TECHNICAL BULLETIN INDEX
Sorted by Bulletin Number
04/03/86

BULLETIN NO: II:1

PRODUCT: 26-4001/2 Model II

Figure 1

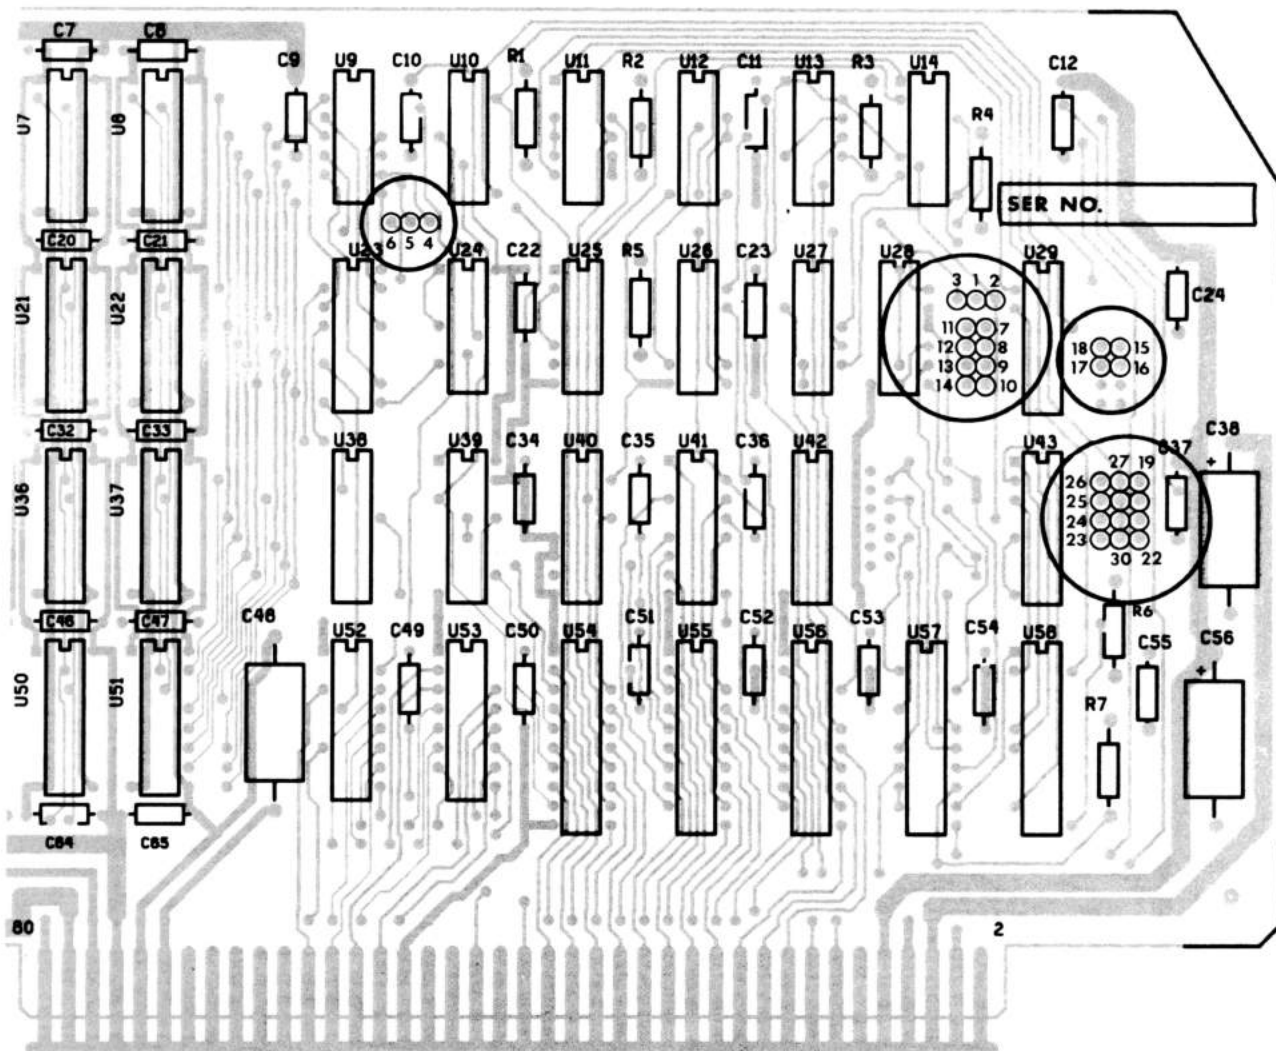
PURPOSE: To correctly identify proper jumper configurations for the Model II Memory Boards.

PROCEDURE: The correct jumper configurations are:

First 32K Memory board:

- 16-17 Selects the first 16K of the base page
- 15-18 Selects the second 16K of the base page

Second 32K Memory board:

- 26-27 Enables the next jumpers on page 1 of the memory map
- 9-11 Selects the first 16K of page 1
- 10-12 Selects the second 16K of page 1

64K Memory board:

- 16-17 Selects the first 16K of the base page
- 15-18 Selects the second 16K of the base page
- 26-27 Enables the next jumpers on page 1 of the memory map
- 9-13 Selects the first 16K of page 1
- 10-14 Selects the second 16K of page 1

Figure 1

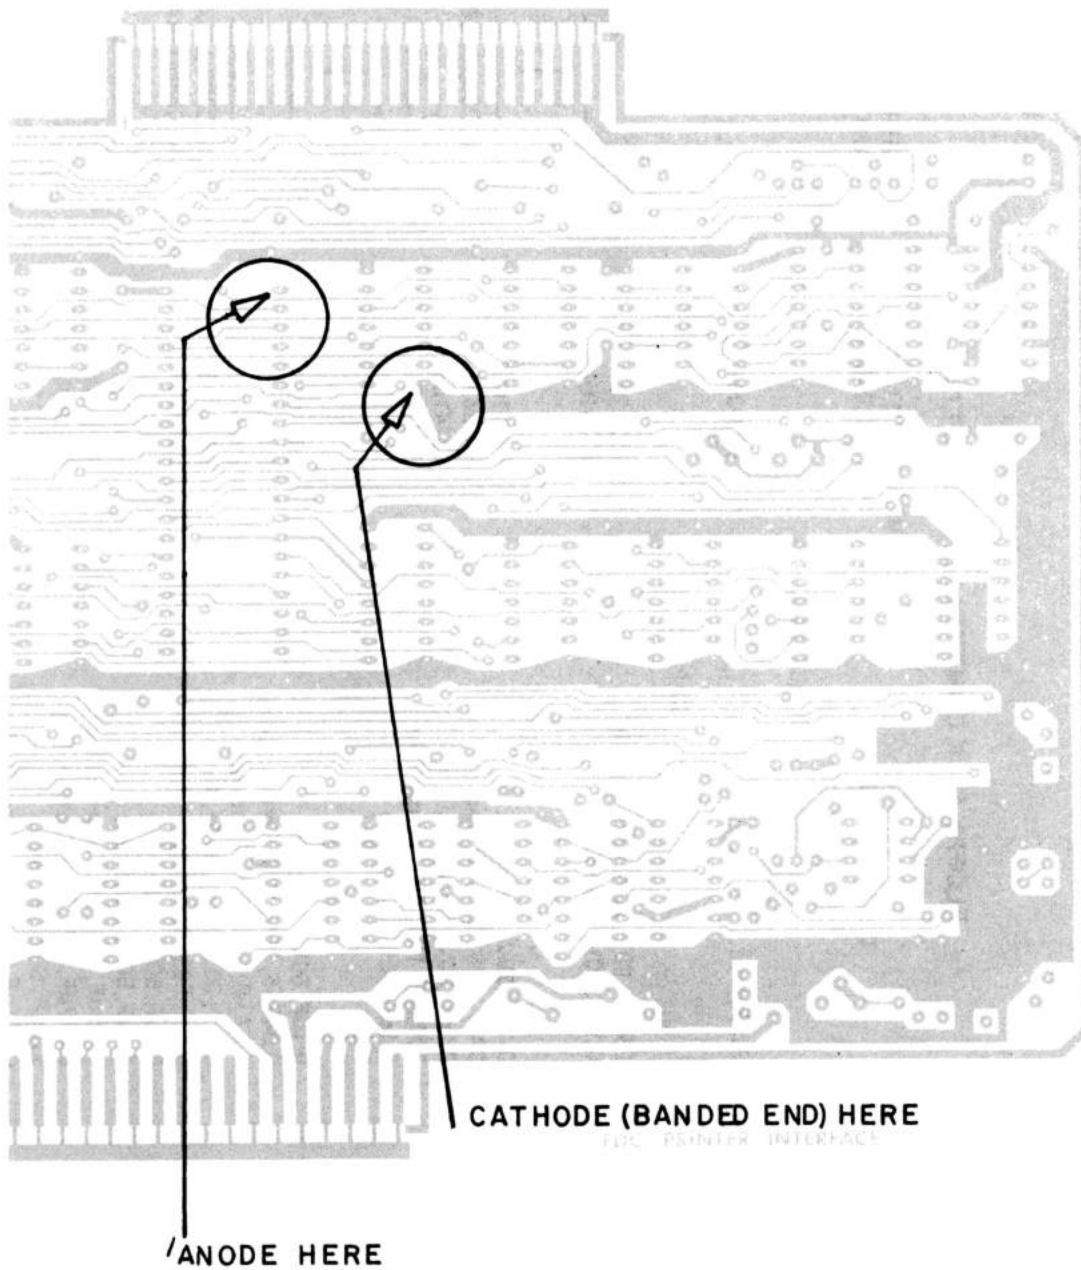
PURPOSE: To correct thermal failure of FDC IC (U6) causing Read/Write errors, and other intermittent disk I/O failures.

DISCUSSION: Early FDC chips developed thermal failures causing disk I/O failures and Read/Write errors. To correct this problem a 2.7V Zener diode MUST be installed from U6 Pin 1 to U5 Pin 7. On new and factory repaired assemblies this change will already have been installed.

PROCEDURE: Check to see if this modification has been done, if not, install diode as per Figure 1. Be sure to use sleeving for insulation of leads to prevent shorts. This diode can be ordered from National Parts using part number ADX-1382 and catalog number 26-4001.

Figure 1

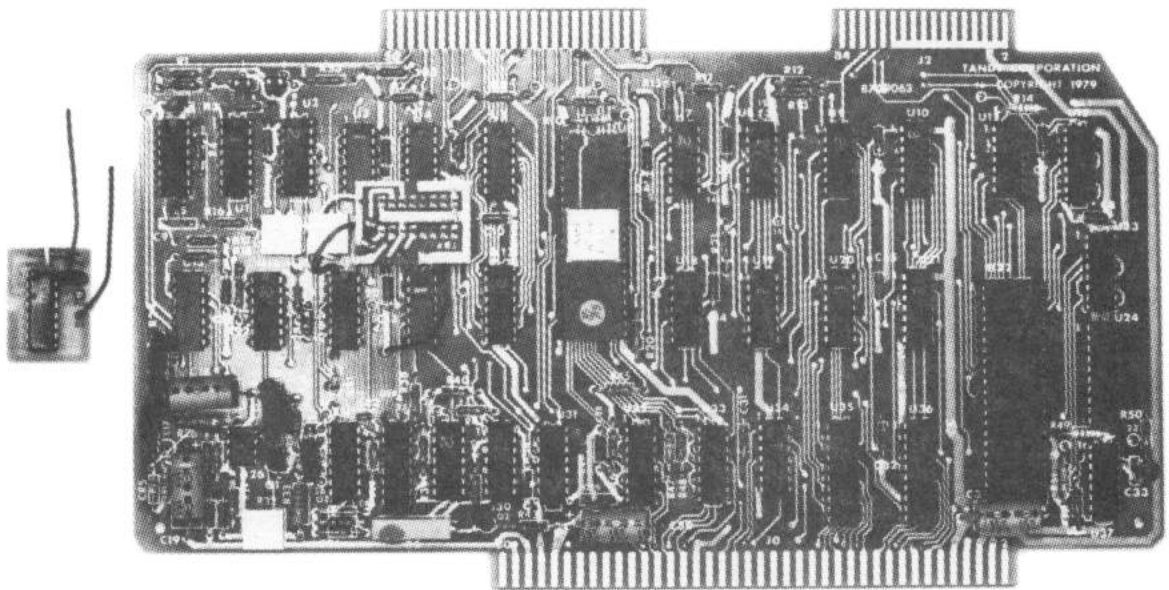
PURPOSE: Identification and modification of FDC boards needing satellite boards.

DISCUSSION: Early Design Rev A and B FDC boards require a modification to stretch the write pulse for proper operation with CDC LSI Logic Boards. This is accomplished by adding a satellite board (AXX-0506) to the existing circuitry. Rev C FDC boards have this modification incorporated on them so the modification is not required. To double check the Rev level of the board locate R49. On Rev B boards R49 is located next to the PIO chip (U22) and on Rev C boards R49 is located between U34 and U35.

Figure 1 is a Rev B FDC Board with the satellite board modification.

1. Cut trace on foil side of the board running from U3 Pin 1 to U16 Pin 3.
2. Dress red, black, and white wires coming from the satellite board to follow the routing shown in Figure 1.
3. Remove solder from the PCB pad that is to receive the stake pin. This is the pad connected to U16 pin 3.
4. Invert satellite module, insert stake pin, and solder the stake pin into place.
5. Reflow solder in unused PCB pads while inserting tinned satellite module leads as shown in Figure 1.
6. Align the FDC board as outlined in the FDCALG diagnostic alignment procedures. Alignment is **MANDATORY** after performing this modification.

Figure 1

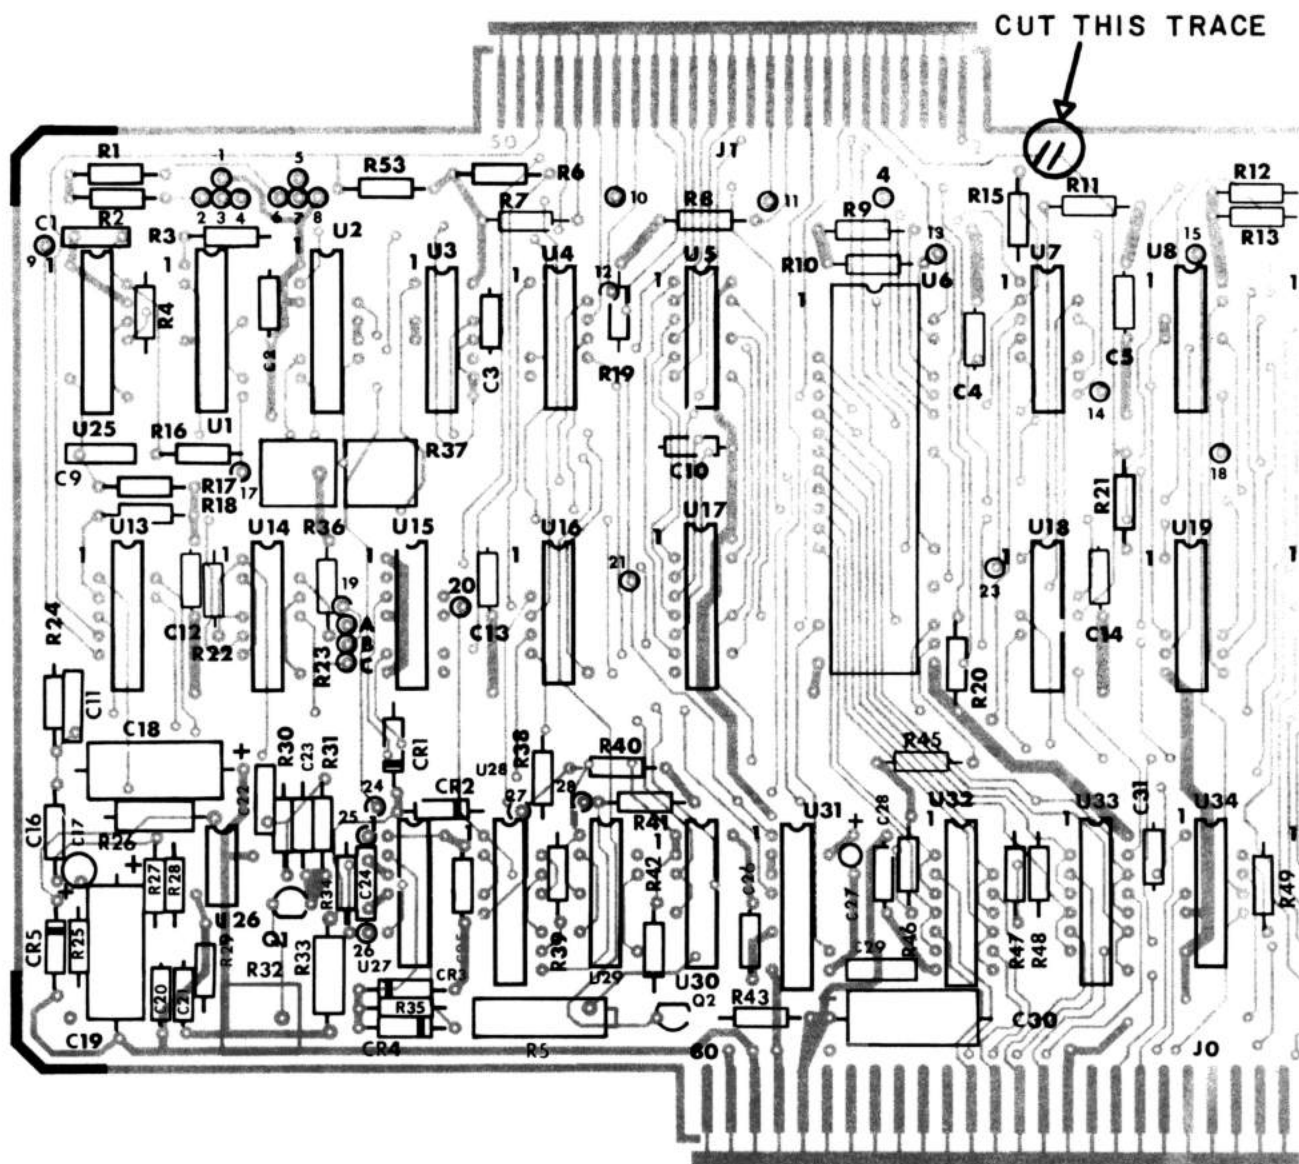
PURPOSE: To prevent Xenix from thinking there is a double sided disk in drive 0 when a terminator is used.

DISCUSSION: The terminator that is used with the Model II ties pin 10 of the disk drive card edge to pin 34. This takes the direction line (pin 34) and connects it to a previously unused line (pin 10) which has a pullup resistor R21 installed on it. Xenix looks at pin 10 to determine if the diskette in the current drive is single or double sided. With the terminator installed this signal will change depending on the direction the drive was last stepped. To correct this problem the trace connected to pin 10 of the FDC board should be cut. This will prevent the customer from being able to use double sided drives, which Radio Shack does not support in the Model II. This modification should only be done to Model IIs that have the 26-6010 enhancement kit installed and an old style FDC board.

PROCEDURE: Locate and cut the trace connected to pin 10 of the disk drive connector on the FDC board (Refer to Figure 1).

FIG 1 OLD PSU WIRING

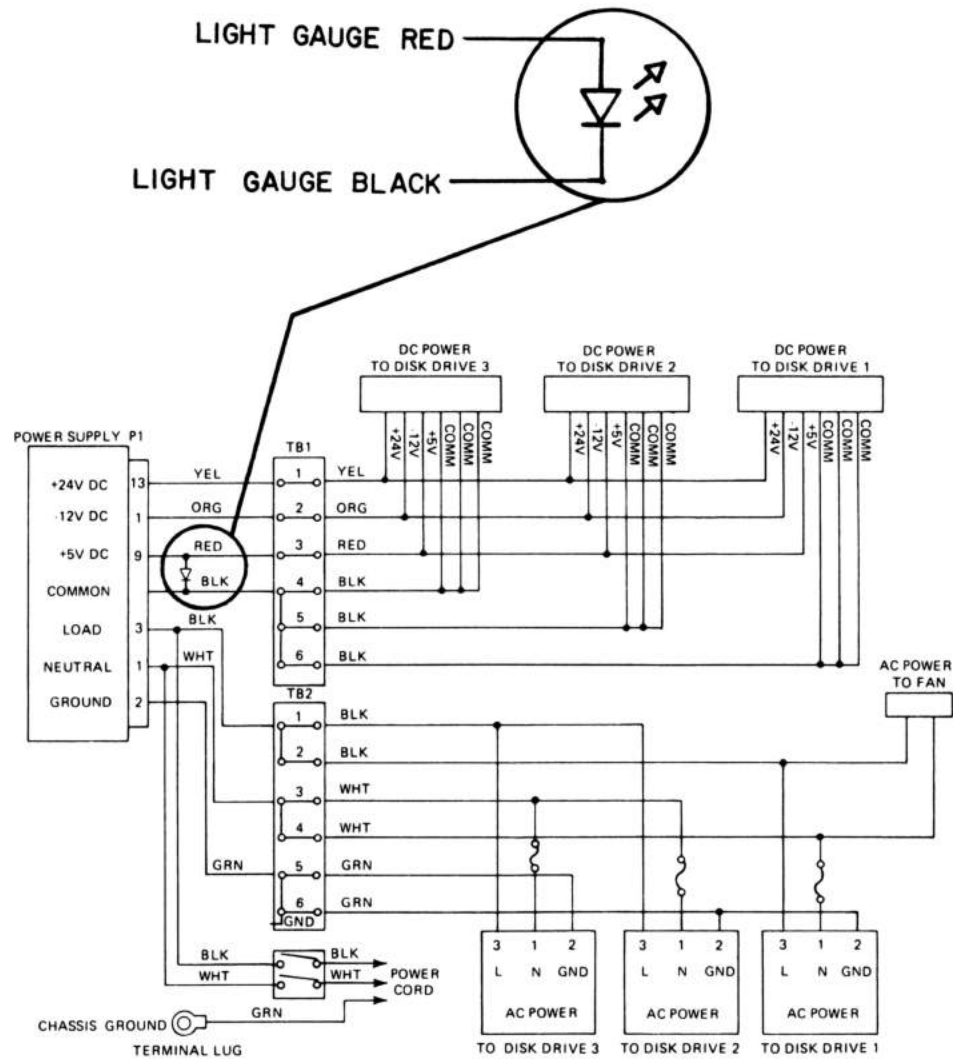
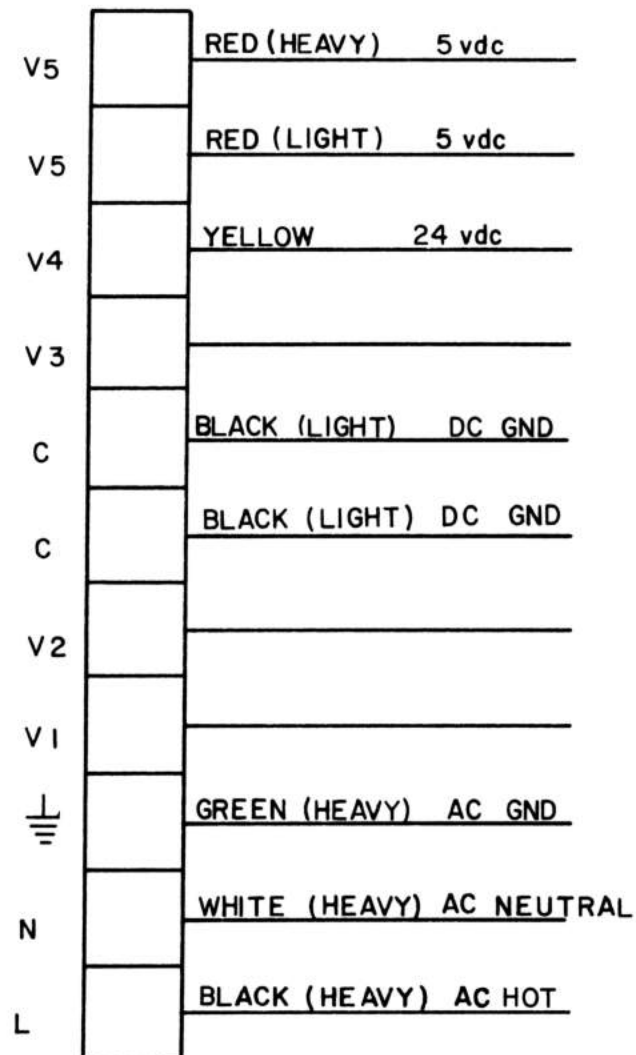
PURPOSE: To discuss wiring differences between early power supply (closed case) and later power supply (open case) in expansion bay.

DISCUSSION: The later style (open case) power supply is labeled differently than the early style (closed case) power supply used in the Model II expansion bay. The wires in the expansion bay are rated as follows:

PROCEDURE: Refer to Figure 1 for the early version power supply (closed case) wiring diagram. Refer to Figure 2 for the later version power supply (open case) wiring diagram.

Figure 1

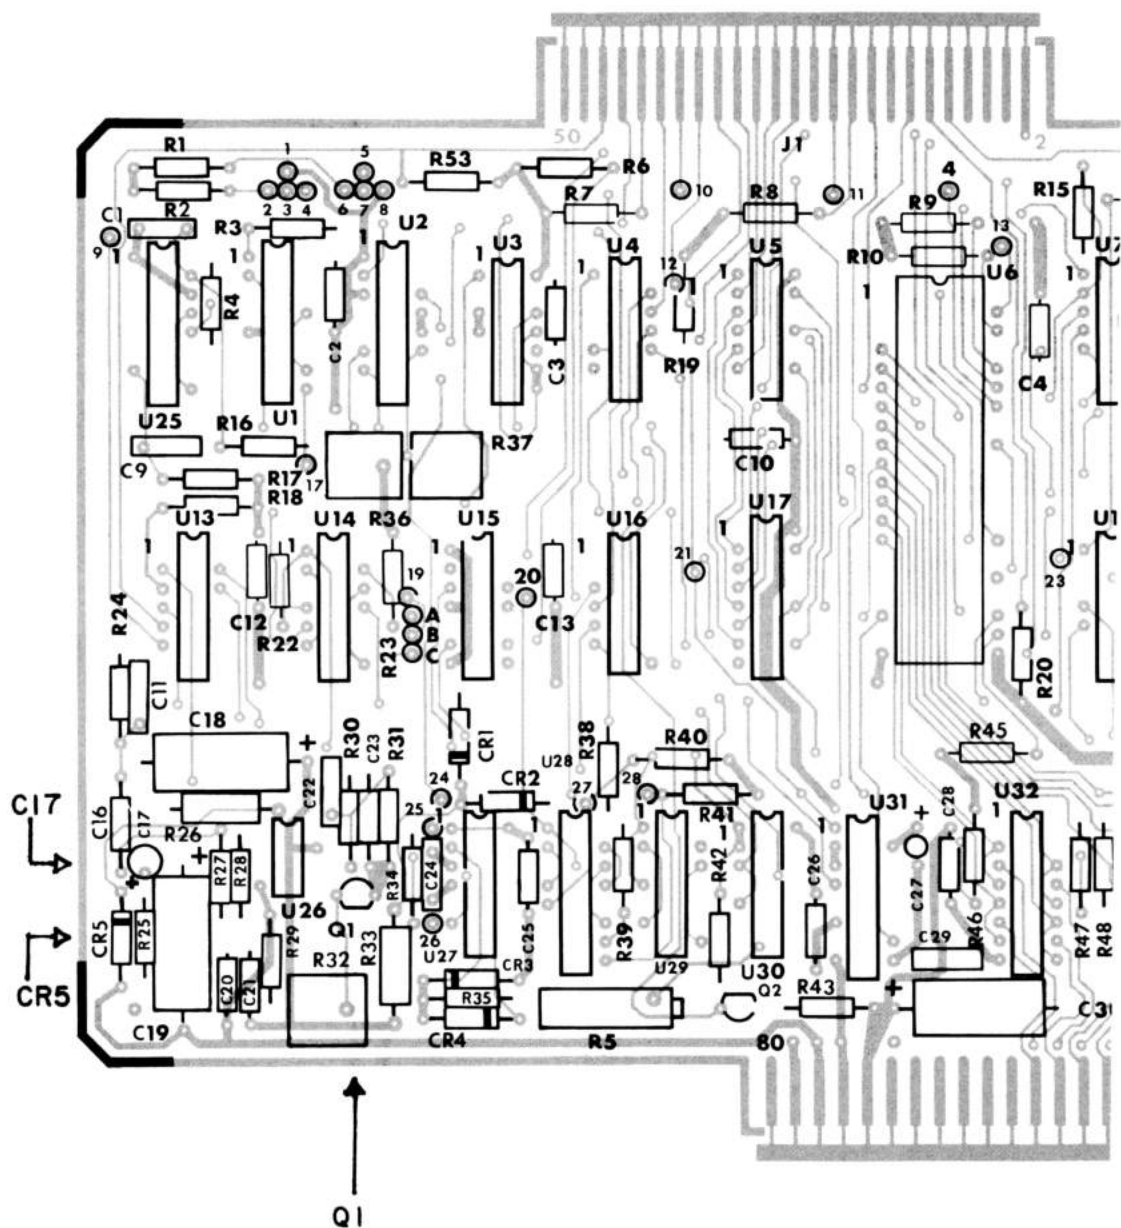
PURPOSE: To correct FDC Boards which have C17 installed backwards.

DISCUSSION: Early FDC boards had a problem with C17 installed backwards. Rev A boards were not marked with polarity. Rev B boards and early Rev C boards were marked with the polarity backwards. This problem was corrected on later Rev C boards. C17 is a .47 ufd tantalum capacitor with a 33V rating. Installed backwards it will eventually break down due to approximately -6V across the capacitor. Note that CR5 is referenced to -12V. This capacitor installed backwards can cause intermittent problems and will eventually cause circuit failure. Over a period of time the capacitor will smoke causing CR5 and possibly Q1 to be damaged.

PROCEDURE: Check C17 on all units in for service to insure the positive(+) lead is going to ground. The most accurate method of checking this is by actually checking with an ohm meter continuity between the positive lead of C17 to ground. If capacitor is installed backwards replace with a new .47ufd tantalum capacitor(ACC-474MGTP). Do not just turn the old capacitor around as it has started degrading and life expectancy shortened.

If the capacitor actually smoked then you must replace it and the diode CR5 (ADX-1279). Also check Q1, a 2N2222A transistor (AMX-4263), because it may have been damaged also, replace if necessary.

FIG. 1

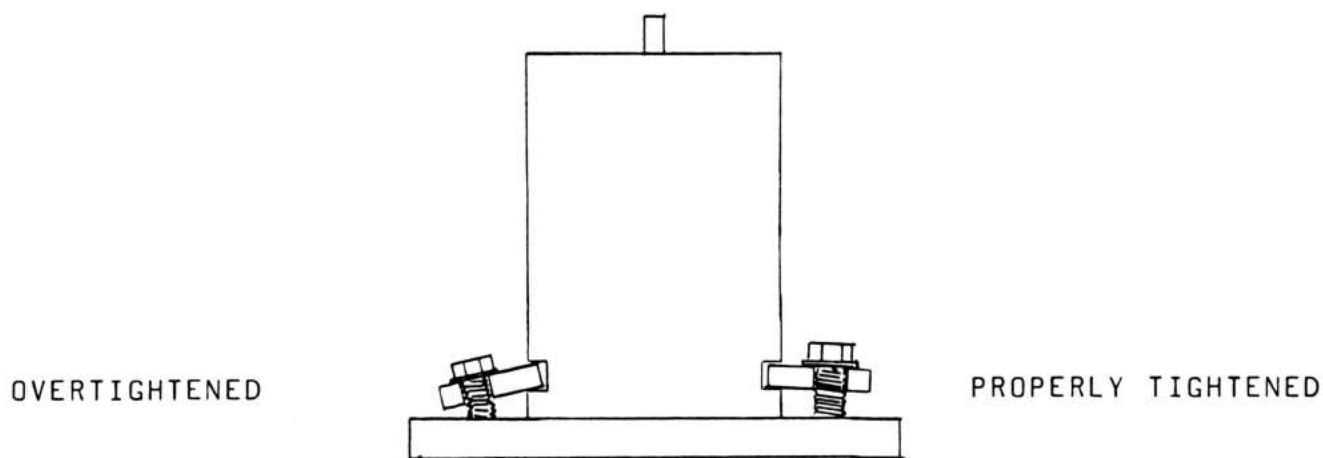
PURPOSE: Explain proper tightening of stepper motor bracket screws after Head Radial Alignment.

DISCUSSION: After aligning Head Radial DO NOT OVERTIGHTEN bracket screws when securing the stepper motor. Excessive tightening will cause bracket and screws to bend and eventually damage the screw holes in the stepper motor plate, making proper alignment almost impossible.

PROCEDURE: After Head Radial Alignment tighten bracket screws only enough to secure stepper motor. If the stepper motor cannot be secured without excessively bending the bracket (Refer to Figure 1), or if the screw holes in the plate are damaged, replace the drive chassis.
